TERMINATION AND RELEASE OF DRAINAGE COVENANT

Drainage File No. H16-D109

DRAINAGE CALCULATIONS
for
SHONEY'S SUITES

RE: GRADING & DRAINAGE PLAN FOR SHONEY'S SUITES (H16-D109)
RECEIVED JULY 18, 1995 FOR BUILDING PERMIT
ENGINEER'S STAMP DATED 7-10-95

PROJECT SHONEYS HOTEL
SUBJECT DRAINAGE CALCS
BY GJK DATE 4-20-95
CHECKED _____ DATE _____
SHEET 18 OF _____

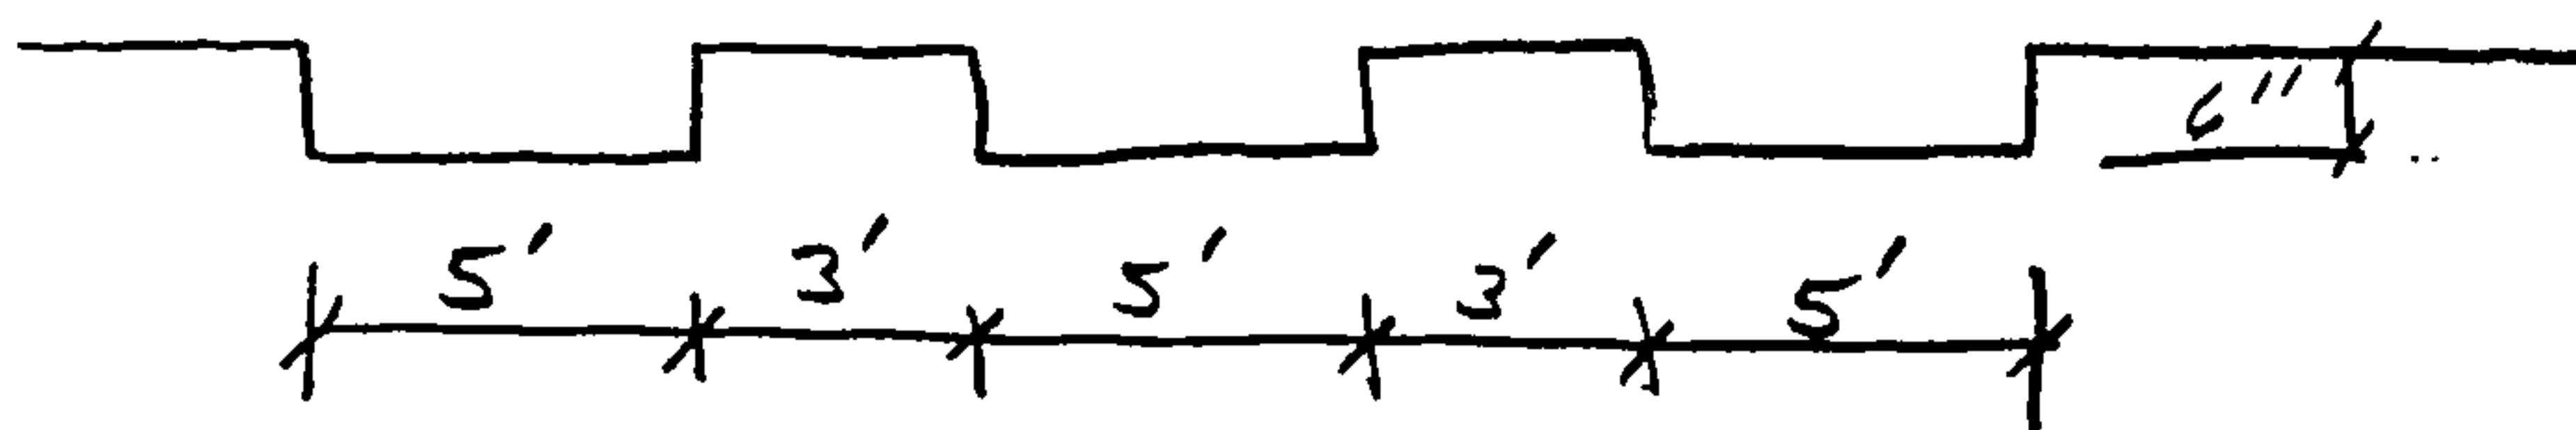
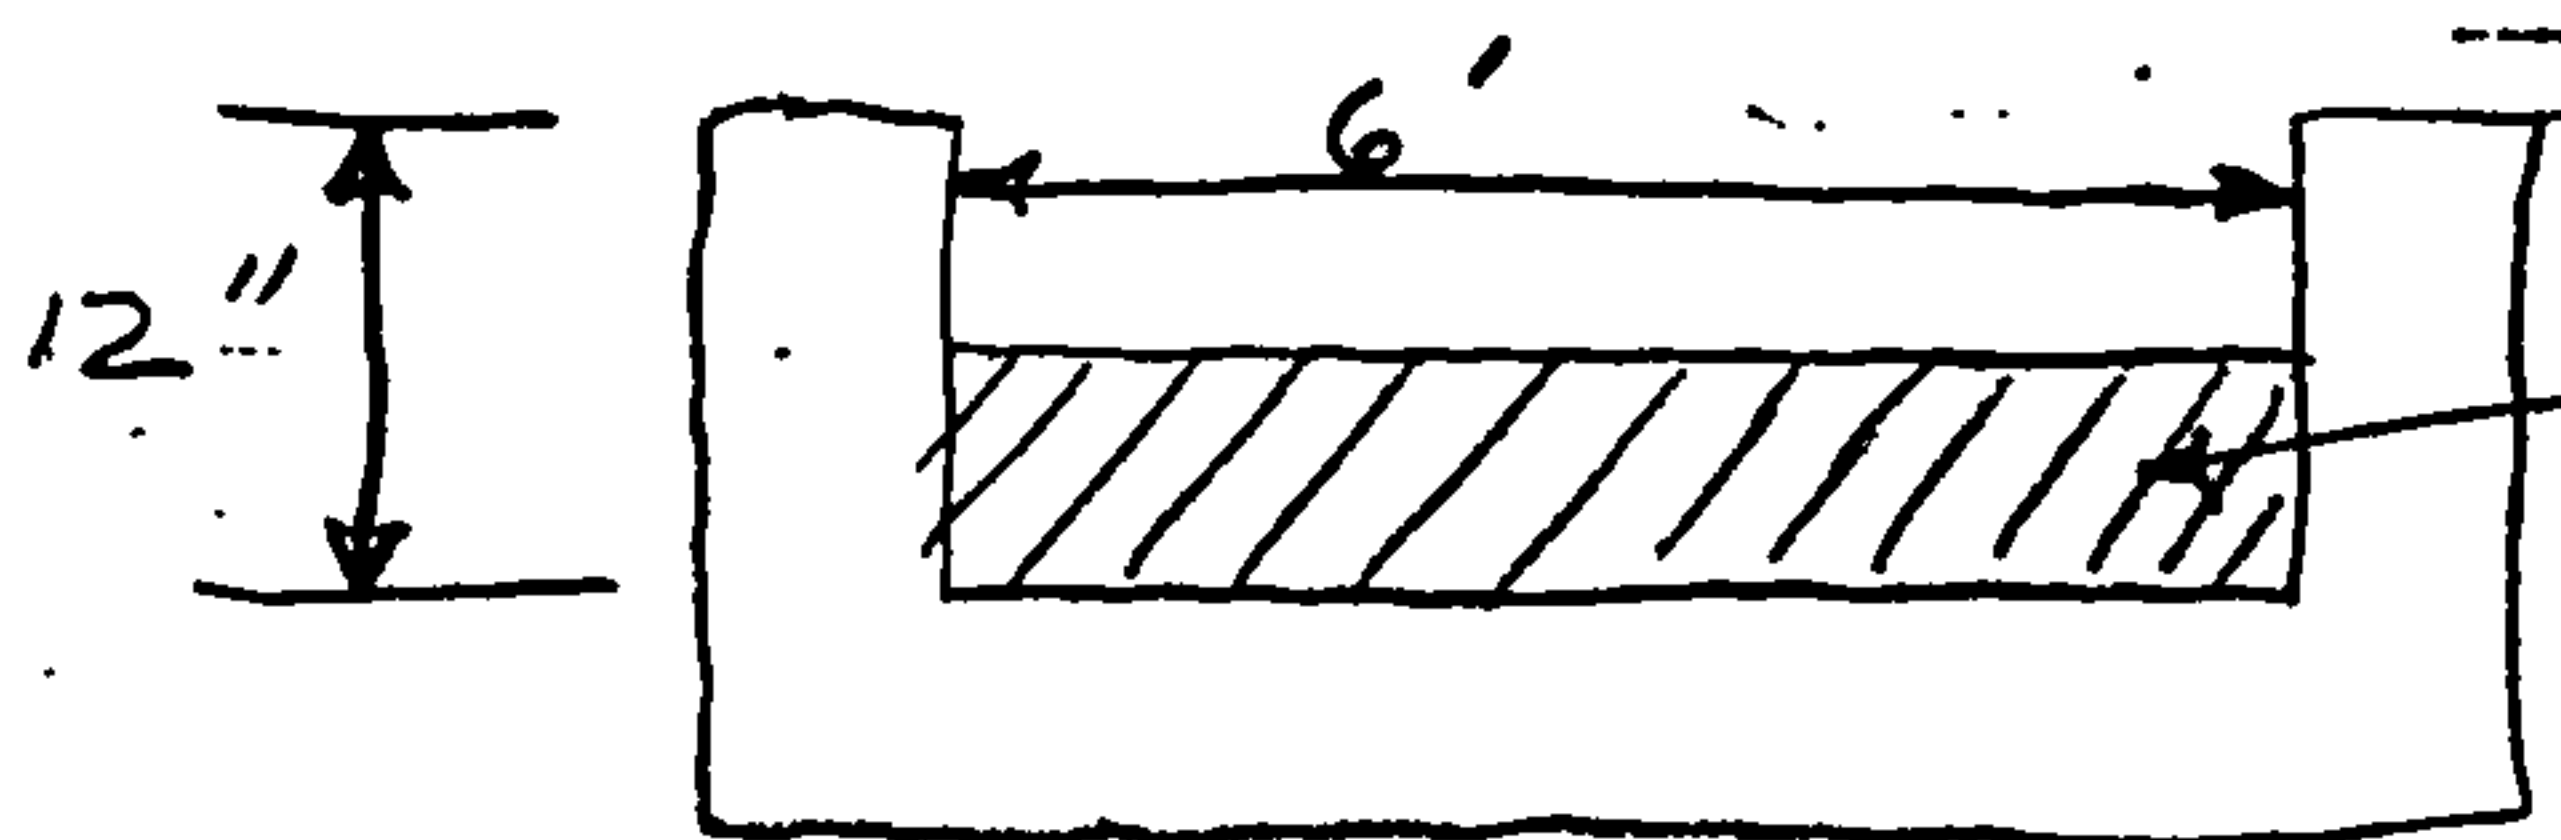
Provide an emergency spillway to protect the berm on the south side of the pond from breaching. An alternative would be to eliminate the berm and meet the existing grade at about elevation 5101.

The outfall or spillway for the pond as shown on sheet 18 of the calculations shows that when the pond fills to the elevations at the asphalt curb across the channel, the 24" RCP will be full and the only discharge will be over the asphalt curb weir. The weir as shown can spill the required Q of 10.32 cfs, which is the 100 year value.

Revised 7-17-95 SHEET 18 OF _____

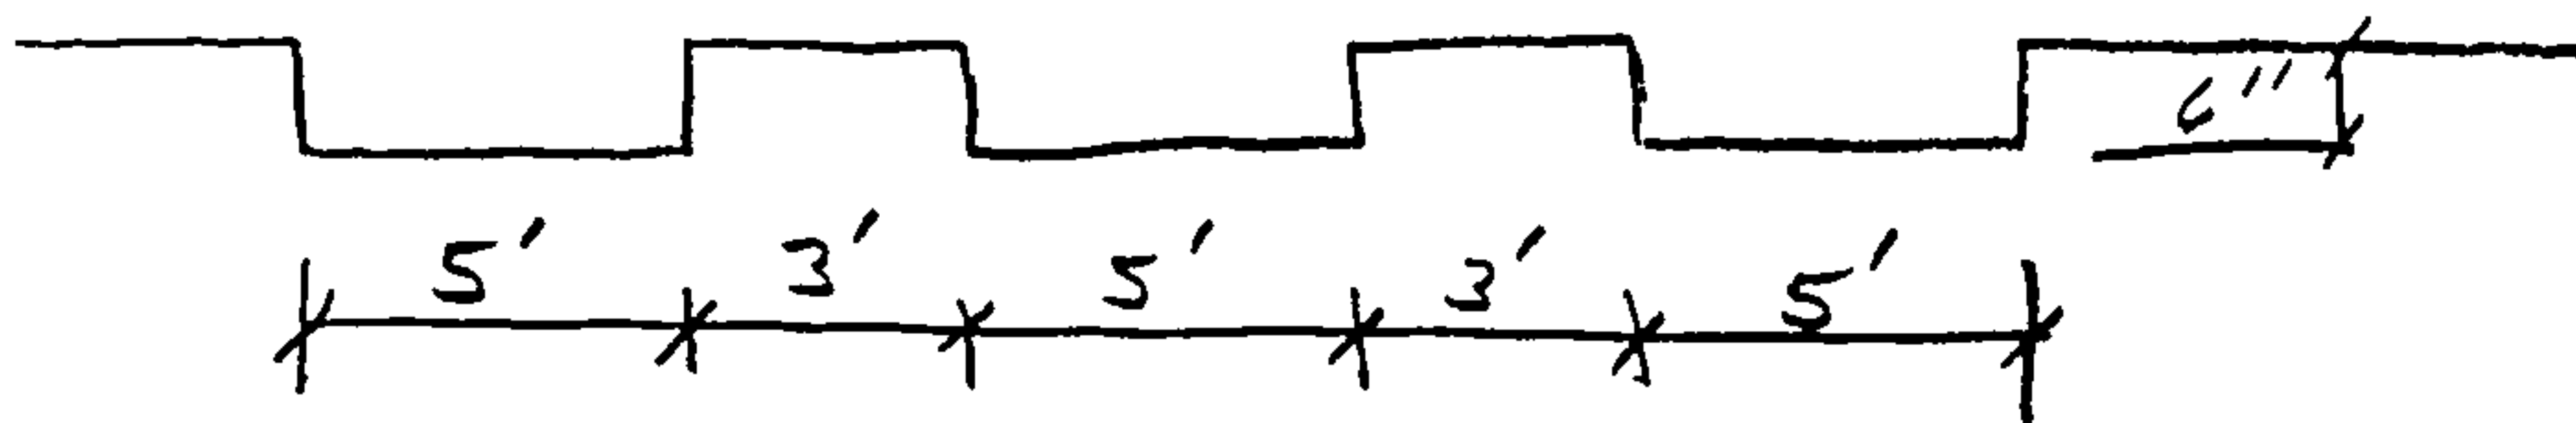
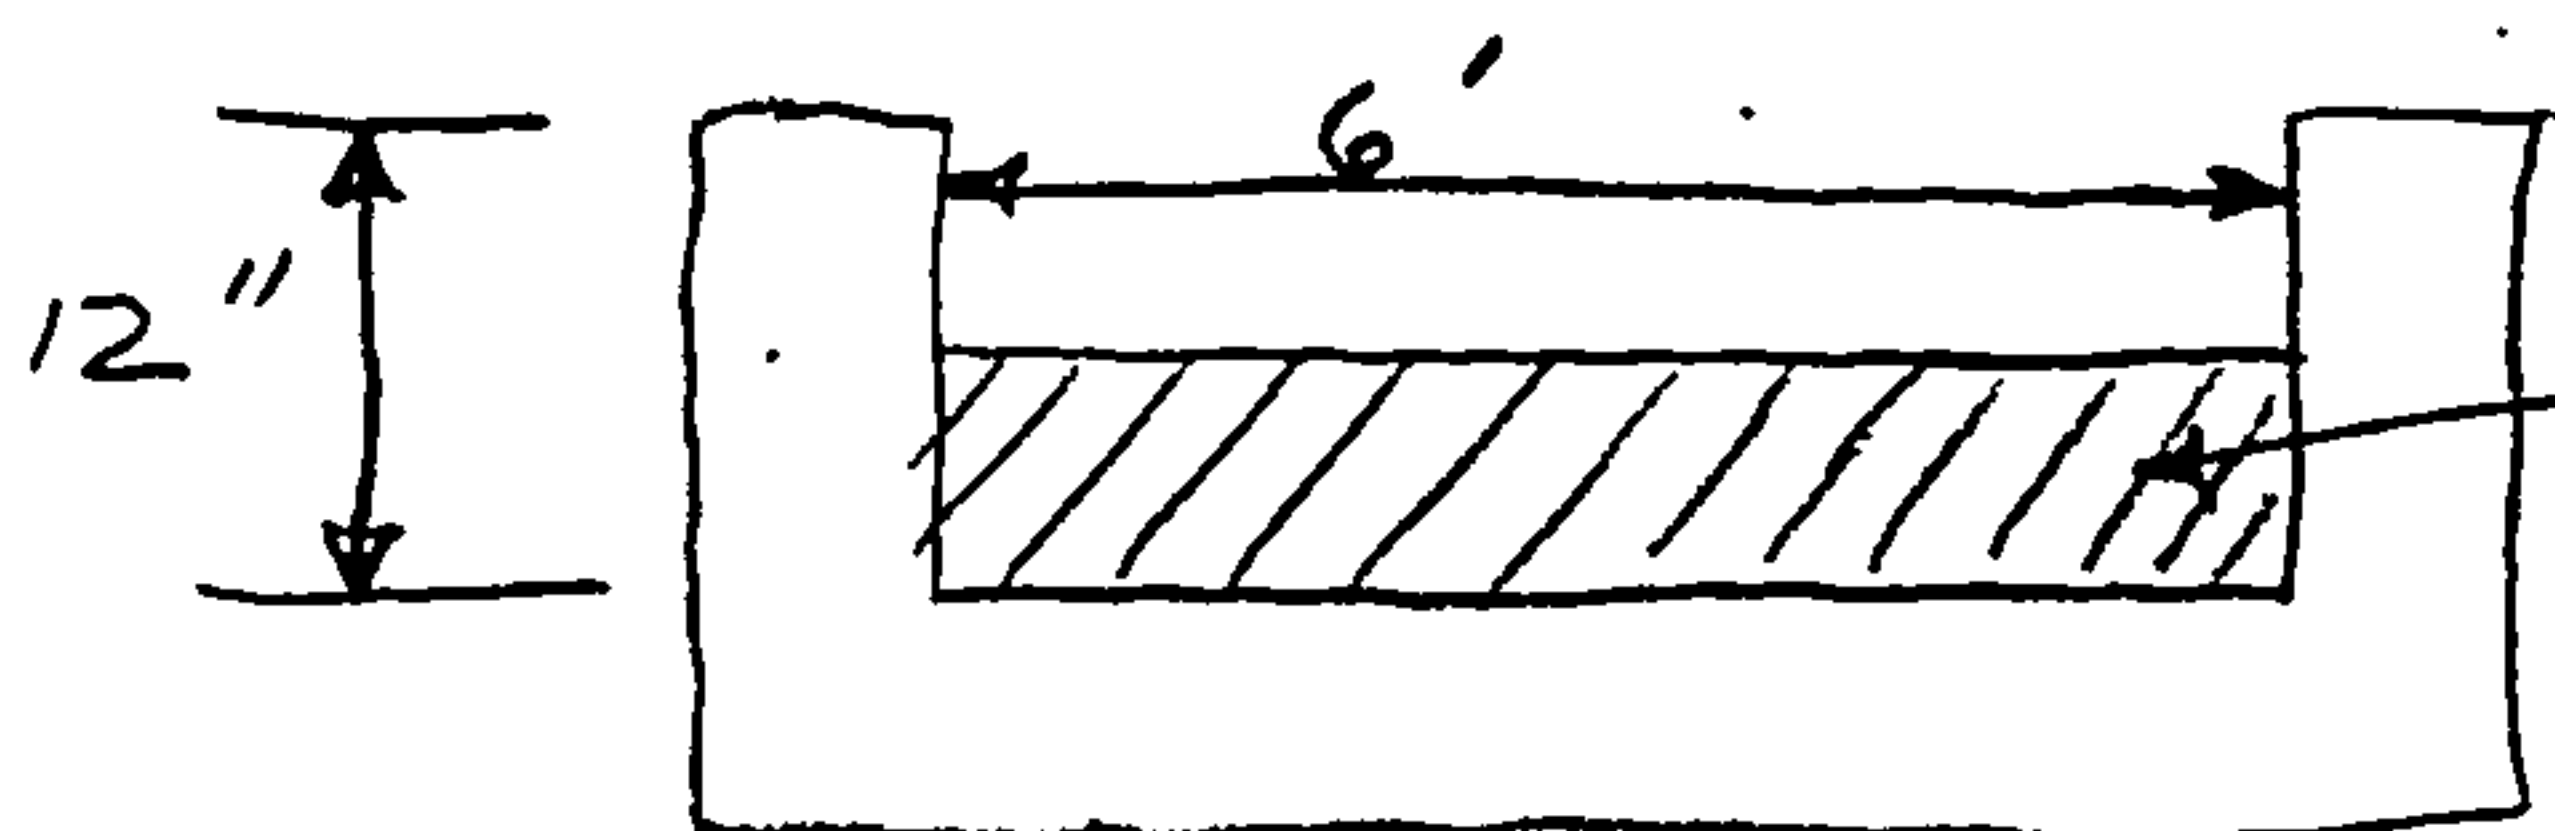
Provide an emergency spillway to protect the berm on the south side of the pond from breaching. An alternative would be to eliminate the berm and meet the existing grade at about elevation 5101.

The outfall or spillway for the pond as shown on sheet 18 of the calculations shows that when the pond fills to the elevations at the asphalt curb across the channel, the 24" RCP will be full and the only discharge will be over the asphalt curb weir. The weir as shown can spill the required Q of 10.32 cfs, which is the 100 year value.
